March 15, 1984
84042.07

Subject: Comanche Peak Steam Electric Station Independent Assessment Program -
Response to CASE Questions

Comanche Peak ASLB Hearings
Response to CASE Questions
Question No.: Walsh #2
Exhibit No.: None

Comanche Peak ASLB Hearings
Response to CASE Questions
Question No.: Walsh #11
Exhibit No.: None
Page 3

Check Flange Bending
 Support No. SI-1-079-001-5325

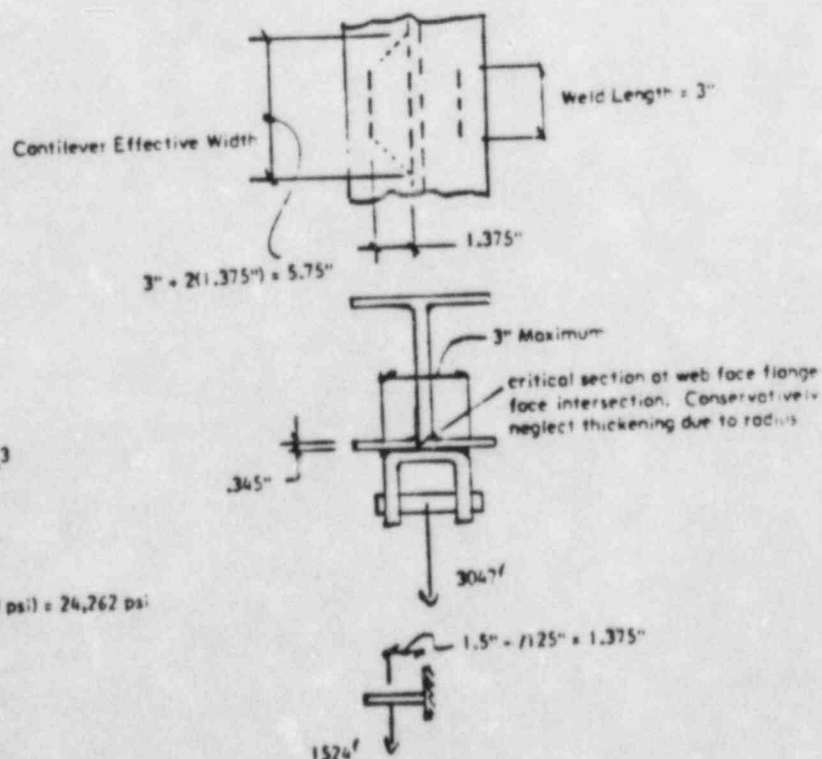
Changing from a flare weld to a fillet weld induces flange bending. Has this been addressed by Cygna?

The calculation sheet attached to Exhibit 893 states that the weldment between the rear bracket and the beam flange was changed from a fillet to a flare/bevel weld. This fillet-to-flare change results in a 90 degree re-orientation of the weld lines, from perpendicular-to-parallel to the web of the wide flange. Did Cygna evaluate the additional loads on the flange?

Cygna judged that this re-orientation would not cause an overstress in the flange. The following calculation verifies that judgement:

$$S = \frac{b^3}{6} = \frac{5.75}{6} (1.345)^2 = .114 \text{ in}^3$$

$$= \frac{M}{S} = \frac{1524(1.375)}{.114} = 18,382 \text{ psi}$$

$$\text{Allowable stress} = .75F_y = .75(32,350 \text{ psi}) = 24,262 \text{ psi}$$

$$18,382 < 24,262 \text{ psi}$$
